# CITY OF ALBUQUERQUE

**Re: Sonic Drive Through  
531 Bridge Blvd. SW  
Traffic Circulation Layout**  
Architect's Stamp 5-12-17 (L14D025A)

Based upon the information provided in your submittal received 5-16-17, the above referenced plan cannot be approved for Building Permit until the following comments are addressed:

## SITE PLAN 1" = 20'

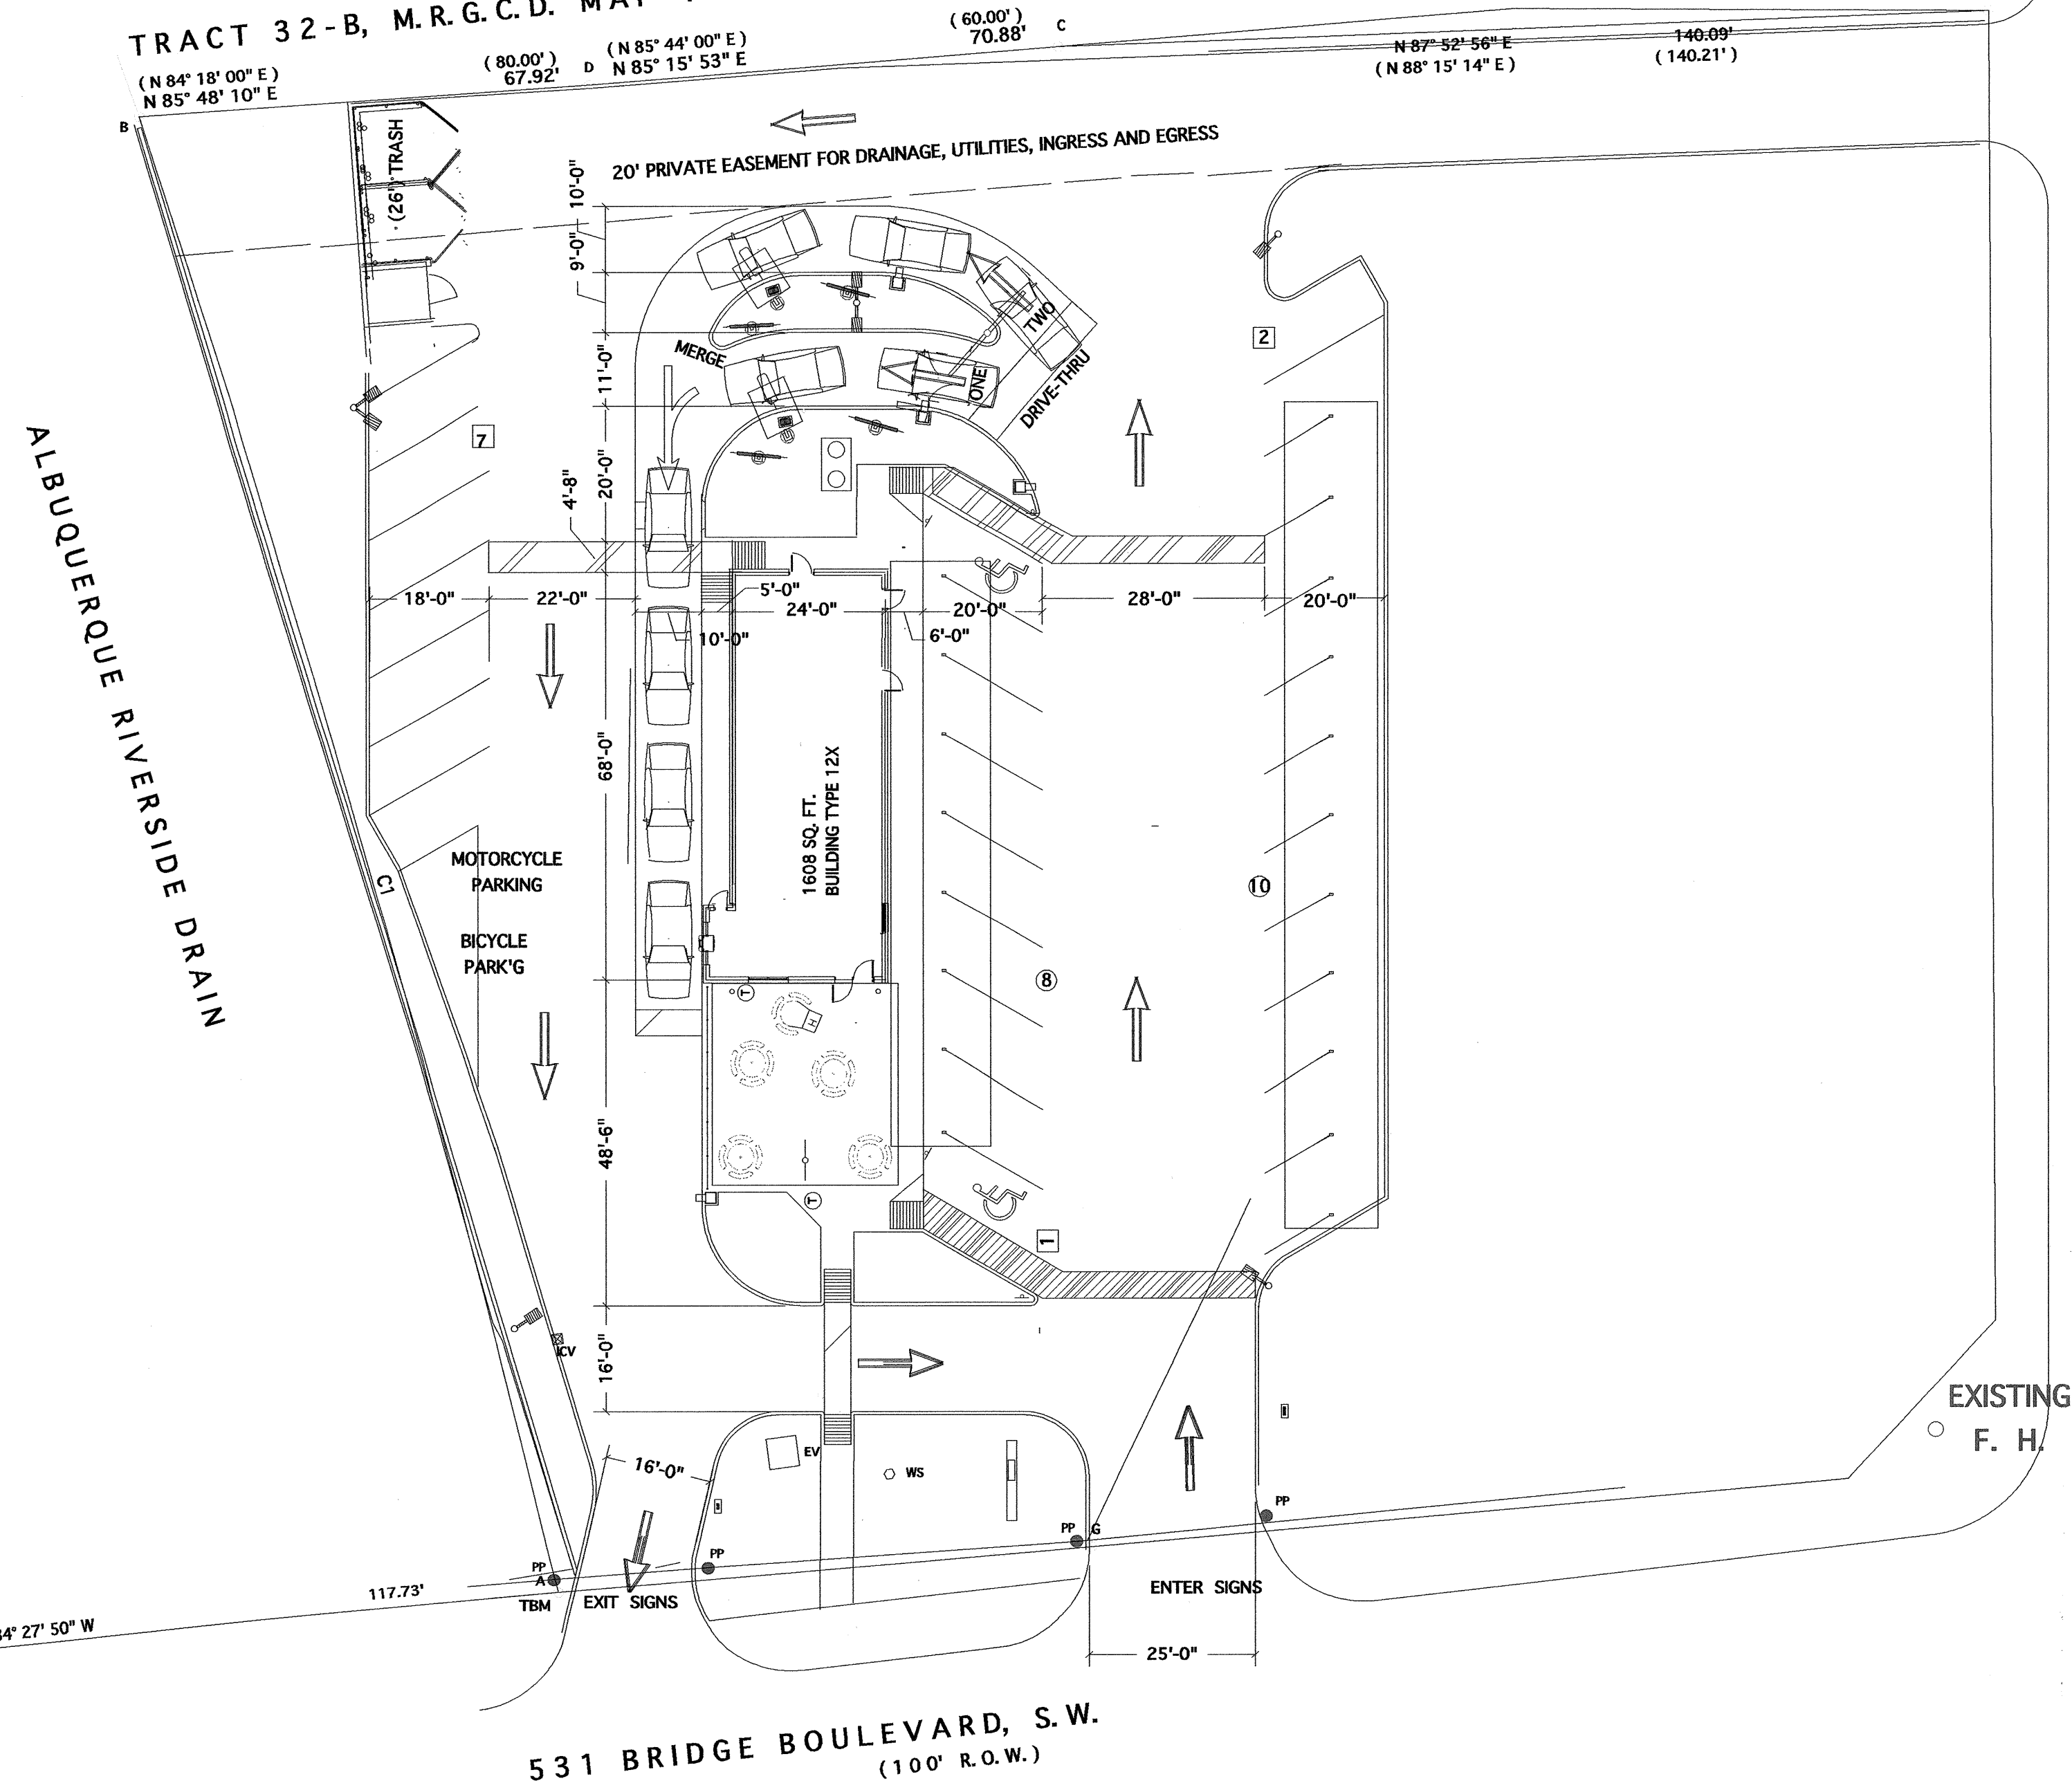
1. The ADA accessible parking sign must have the required language per 66-7-352.4C NMSA 1978 **"Violators Are Subject to a Fine and/or Towing."** Please call out detail and location of HC signs.

2. The ADA parking space has a clearly visible, blue, International Symbol of Accessibility painted on the pavement at rear of the space (66-1-4.1.E NMSA 1978) or MUTCD recommends a white symbol on a blue background.

3. Please dimension all pedestrian path ways. Some dimensions are not shown.
4. Please add the following note to the clear sight triangle: "Landscaping and signage will not interfere with clear sight requirements. Therefore, signs, walls, trees, and shrubbery between 3 and 8 feet tall (as measured from the gutter pan) will not be acceptable in this area."

5. Show all drive aisle widths and radii. Some dimensions are not shown.
6. For drive through facilities the minimum drive through lane width is 12 feet with a 25 foot minimum radius (inside edge) for all turns. (A 15 foot radius can be used with an increase in lane width to 14 feet).

7. List radii for all curves shown; for passenger vehicles, the minimum end island radius for passenger vehicles is 15 ft. Radius for delivery trucks, fire trucks, etc. is 25 ft. or larger.

8. It is not apparent what type of pavement surface is being proposed. A hard driving surface will be required as part of this proposed project for parking area and drive aisles.

9. Label the compact parking spaces by placing the words "COMPACT" on the pavement on each space.
10. Identify the locations of the Motorcycle and Bicycle parking space.
